1999 SEMINAR INFORMATION
"TECH ON TIME FOR '99"
INDEX
FORD & Chrysler

1999 SEMINAR INFORMATION

"TECH ON TIME FOR '99"

In this third manual on "TECH ON TIME FOR '99" seminar, we begin with FORD'S new 4R100. A look at the E4OD, AX4S/AX4N, AODE/4R70W and the 4R44E transmissions are just a portion of the information provided in this section of the seminar. Updates and part changes, problems and fixes for FORD transmissions fills this manual with valuable information. This manual concludes with information on Chrysler units including a look at the new 45RFE.

Figure 1

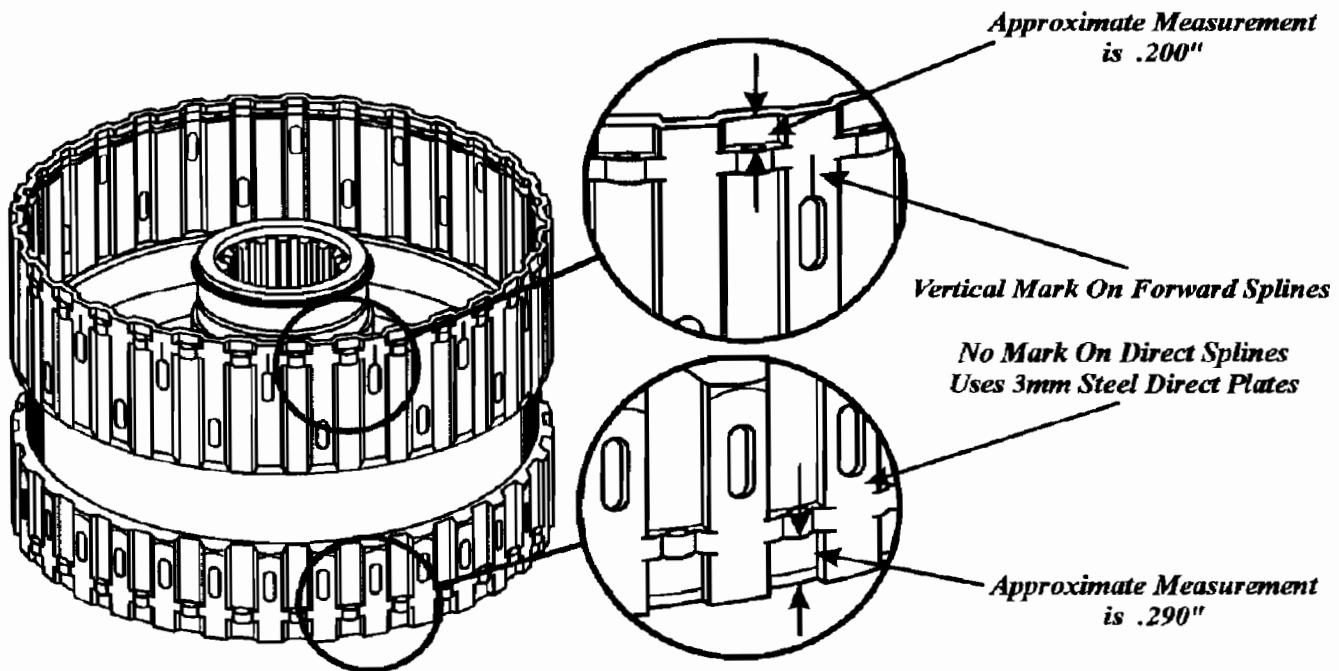
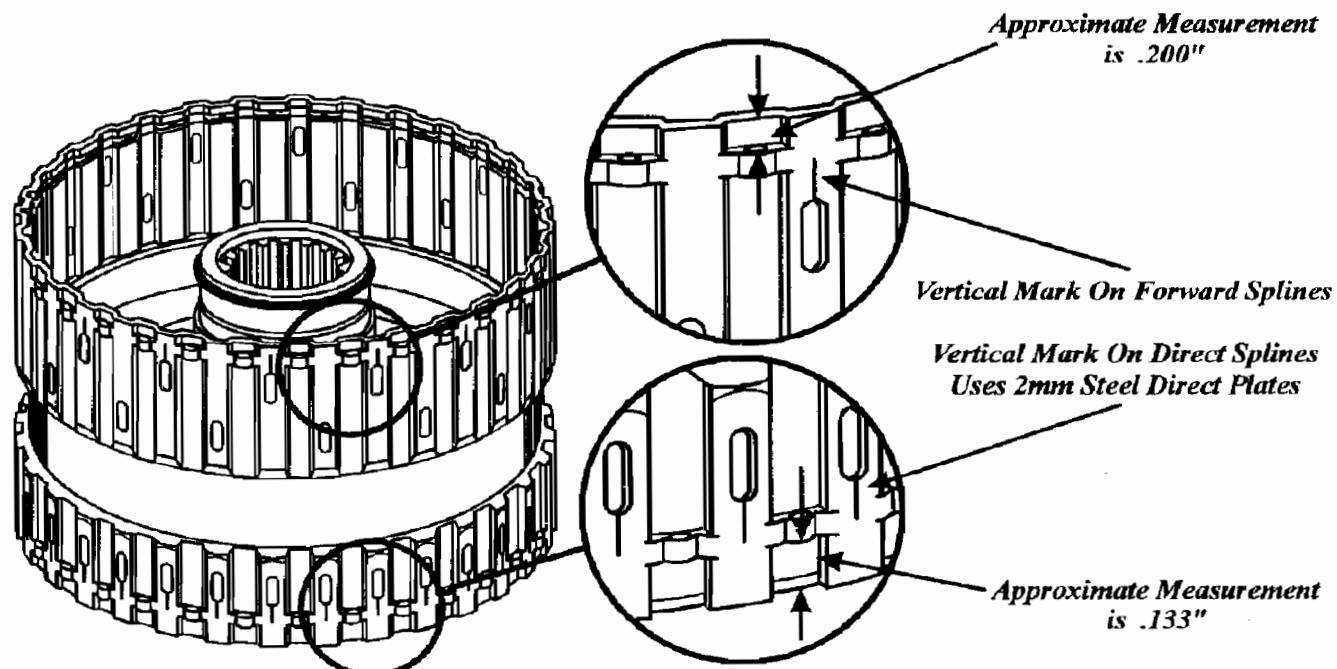
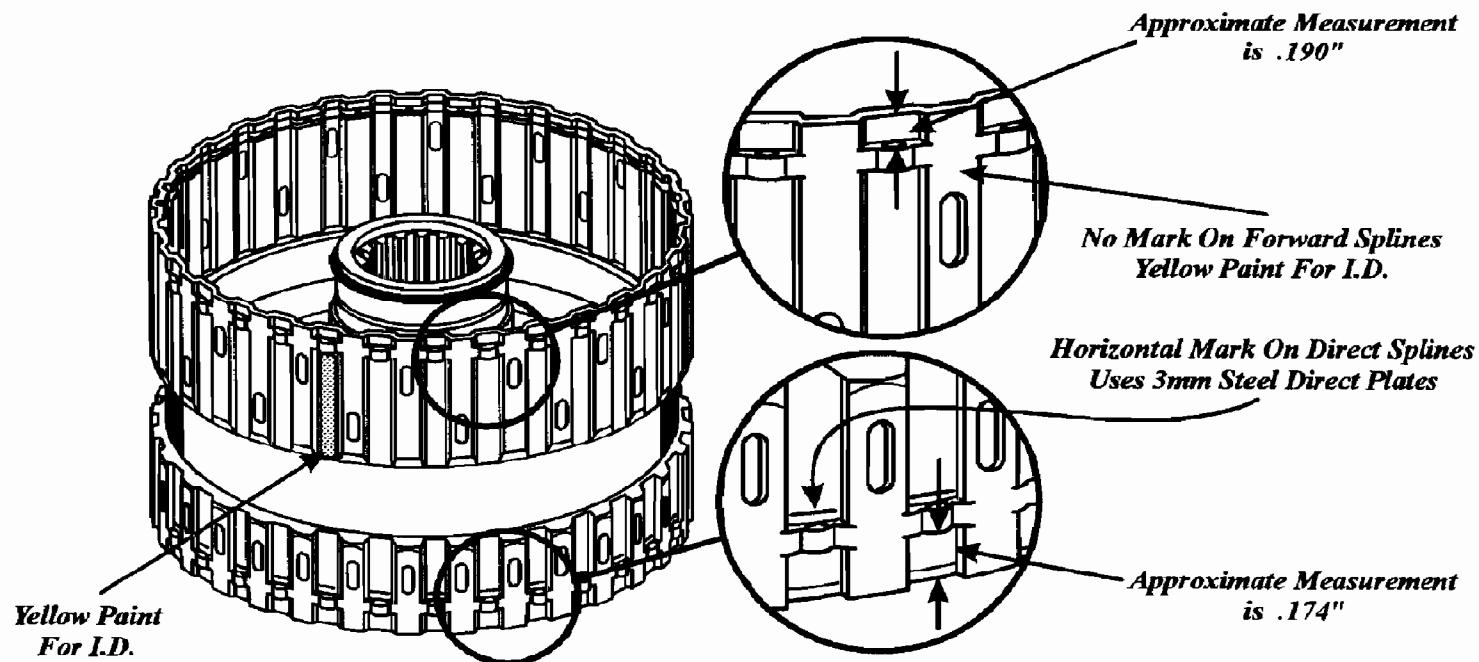
- (1) **FORWARD/COAST/DIRECT CLUTCH HOUSING** - There is a new forward clutch snap ring groove location to help accommodate the addition of the wave plate. This has now created two new clutch housings, one for the 4 cylinder and one for the V6 cylinder, just for the 1998 1/2 models. Identification and approximate dimensions are provided on the new design level clutch housings in Figure 1.
However, we still have 3 different previous design level clutch housings to contend with, which creates a total of five different clutch housings. Identification and approximate dimensions are provided on the previous design level clutch housings in Figures 2 and 3.

Figure 6

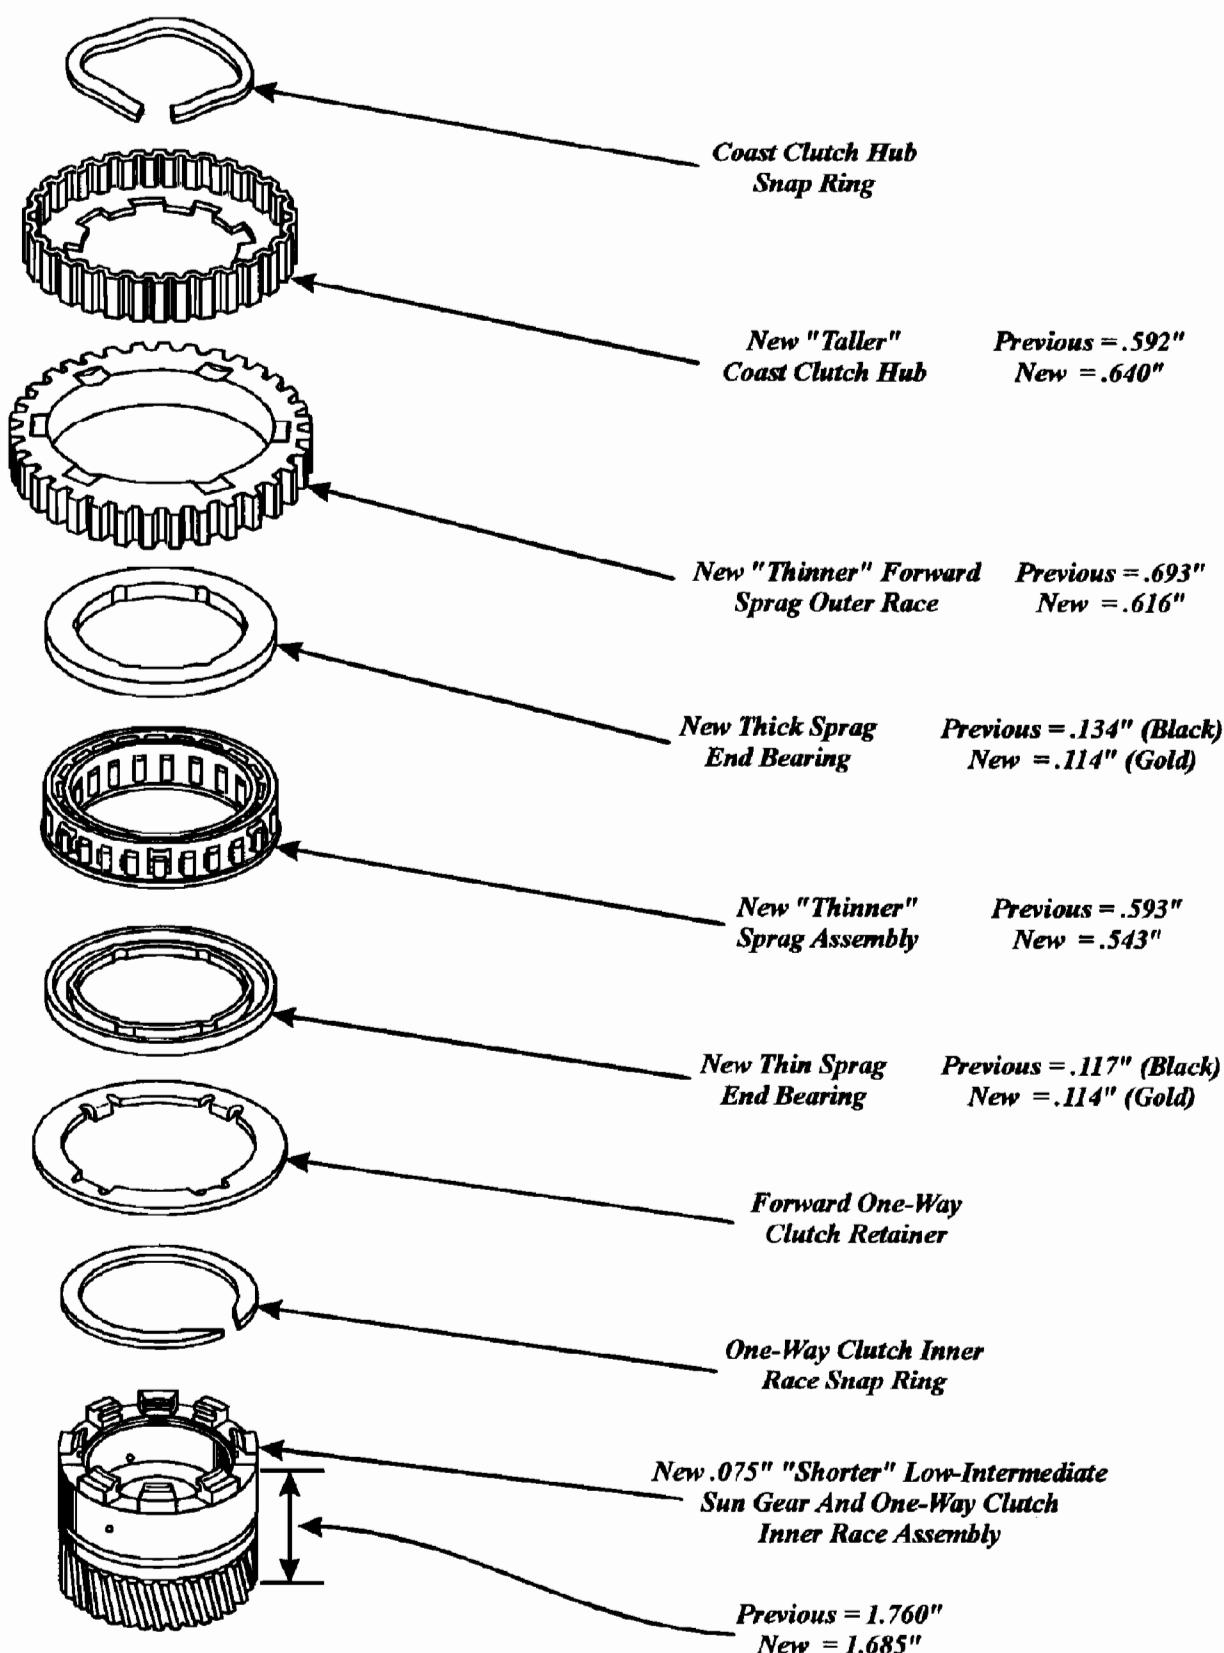
- (9) **FORWARD ONE-WAY CLUTCH AND SUN GEAR ASSEMBLY** - The forward sprag and sun gear assembly is available only as a complete service package of all of the pieces shown in Figure 6 under OEM part number F8RZ-7A089-AA. However, many of the service package parts have revised dimensions that you need to be aware of and are as follows:

- (A) **Coast Clutch Hub Retaining Ring** - No changes. Refer to Figure 6.
 - (B) **Coast Clutch Hub** - Has been made **.053 taller** to accommodate changes in the forward clutch pack, as shown in Figure 6.
Previous Design = .592".
New Design = .640".

- (C) **Forward Sprag Outer Race** - Has been made **.077 narrower** to accommodate the changes in the forward clutch pack, as shown in Figure 6.
Previous Design Cage = .693".
New Design Cage = .616".

- (D) **Thick End Bearing** - Has been made **.020" thinner** to accommodate the changes in the forward clutch pack, as shown in Figure 6. Both end bearings now the same.
Previous Design = .134" (Black in color)
New Design = .114" (Gold in color).

- (E) **Forward Sprag Assembly** - Has been made **.050" narrower** to accommodate the changes in the forward clutch pack, as shown in Figure 6.
Previous Design = .593", Sprag Elements = .372".
New Design = .543", Sprag Elements = .307"

- (F) **Thin End Bearing** - Has been made **.003" thinner** to accommodate the changes in the forward clutch pack, as shown in Figure 6. Both end bearings now the same.
Previous Design = .117" (Black in color).
New Design = .114" (Gold in color).

- (G) **Forward Sprag Retainer** - No Changes. Refer to Figure 6.
 - (H) **Forward Sprag Retaining Ring** - No Changes. Refer to Figure 6.
 - (J) **Forward Sprag Inner Race And Sun Gear Assembly** - Has been made **.075" shorter** to accommodate the changes in the forward clutch pack, as shown in Figure 6.
Previous Design = 1.760".
New Design = 1.685".

Figure 7

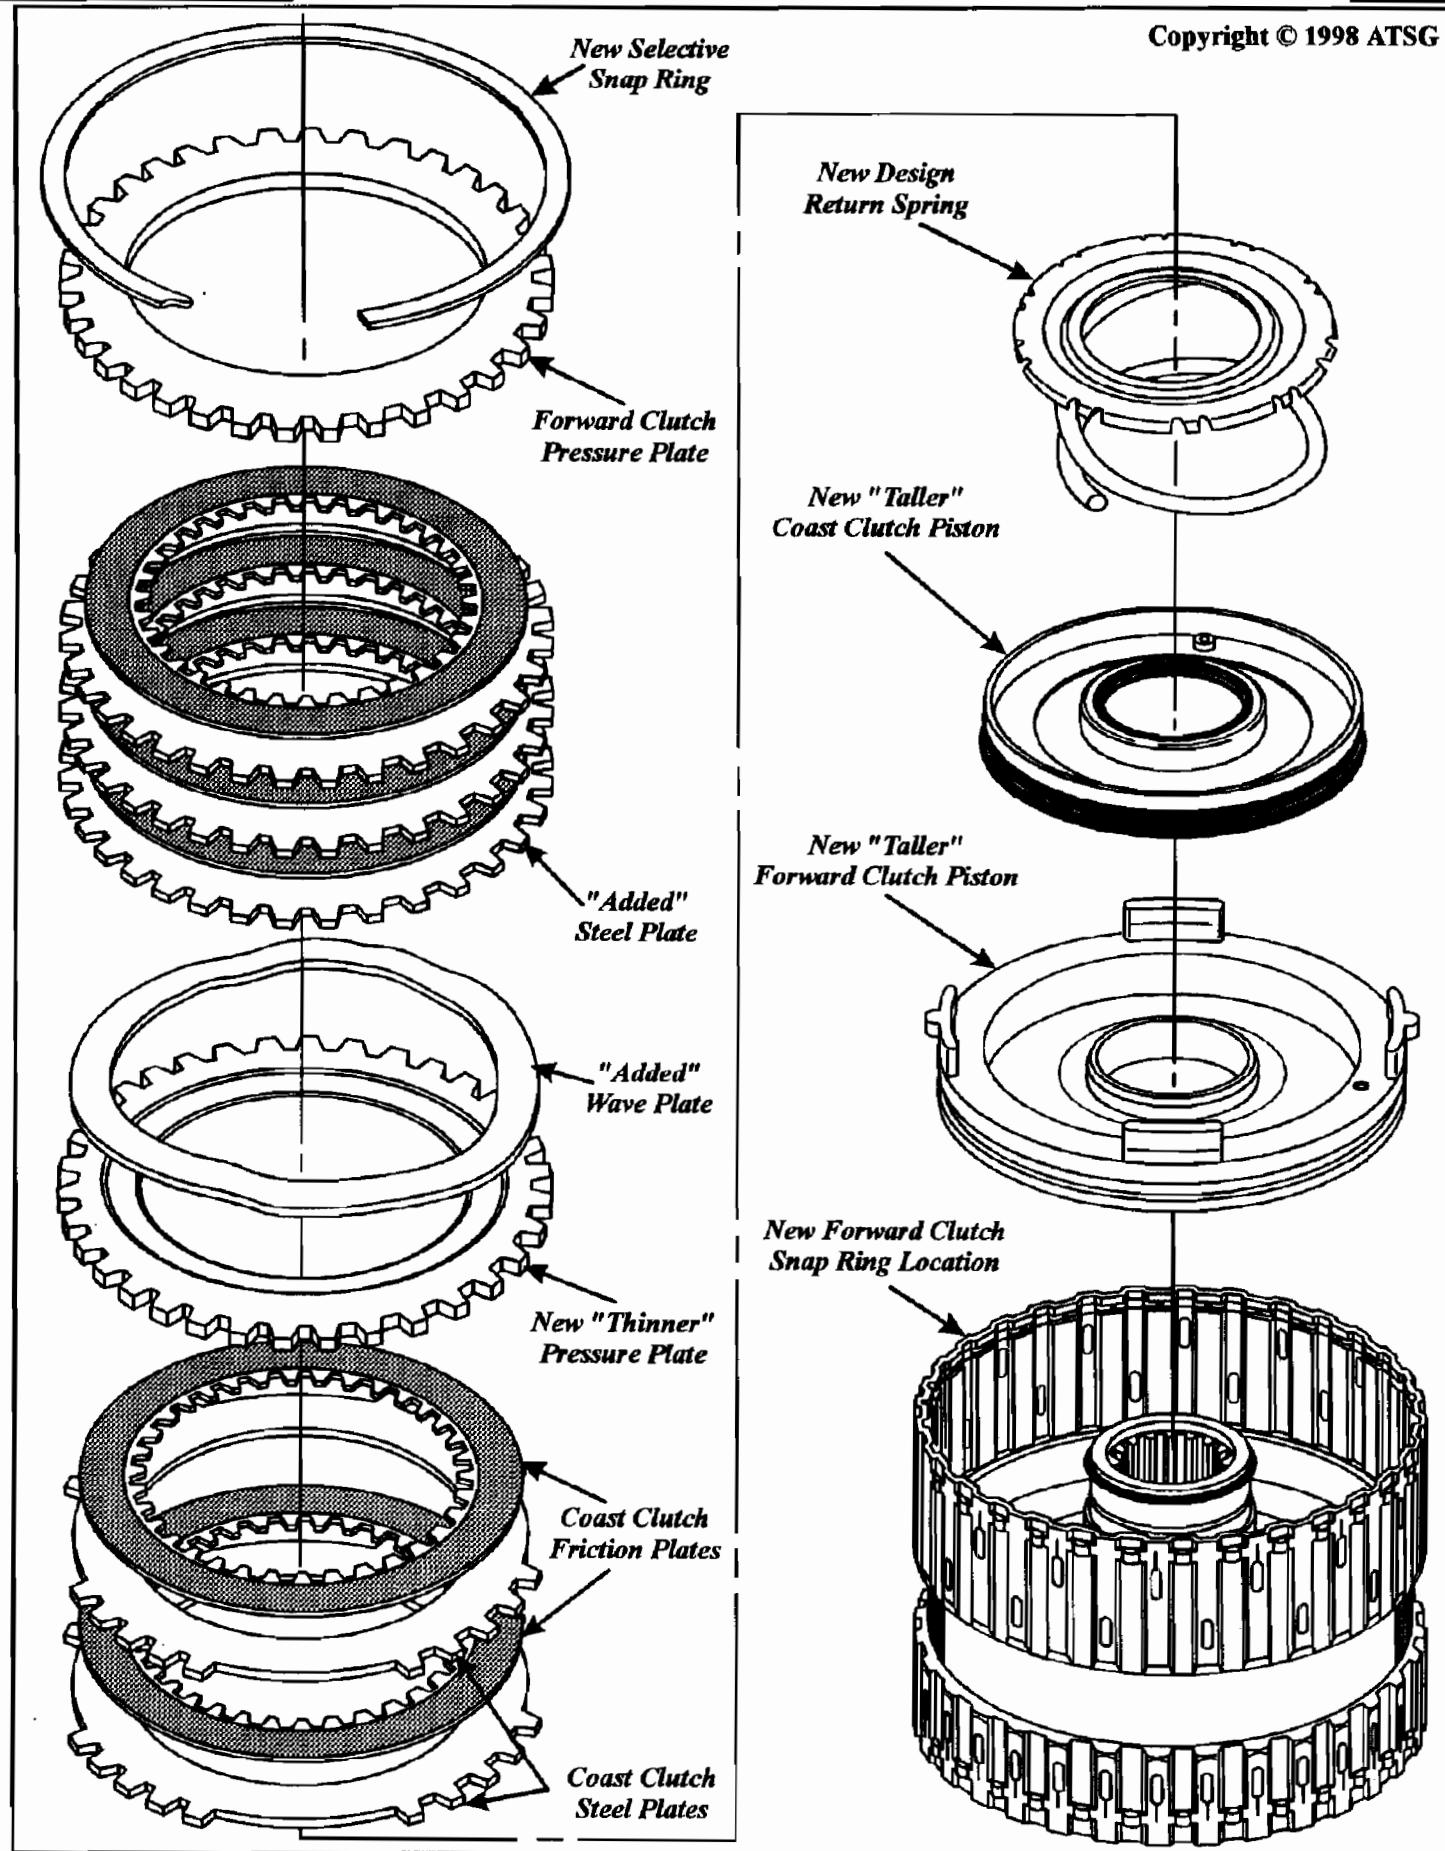
Refer to Figure 7 to ensure that you have the new design level parts assembled correctly.

Figure 1

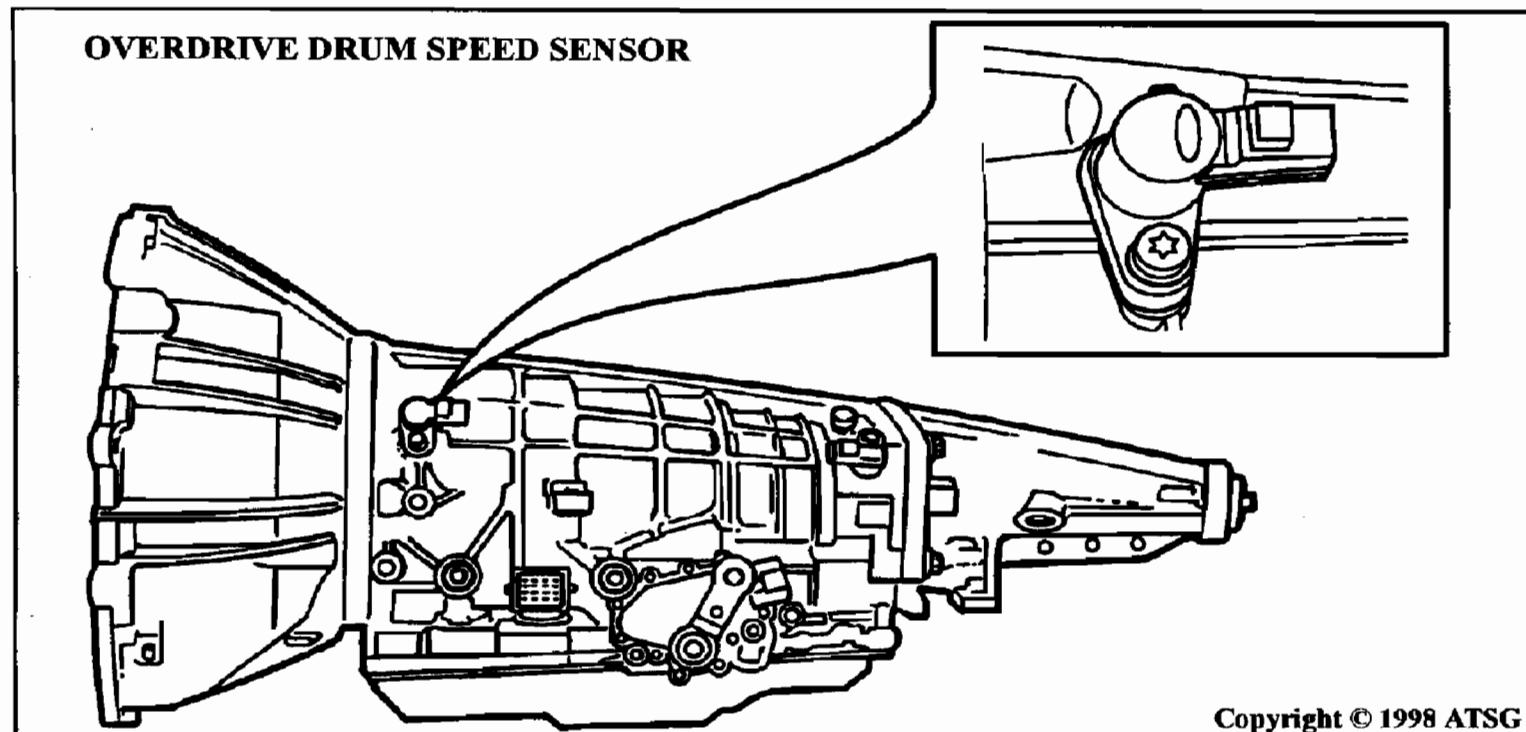
CHANGE: The Overdrive Drum Speed (ODS) Sensor, located in the transmission at the front of the case, was eliminated as a running change during the 1997 model year. Refer to Figure 1.
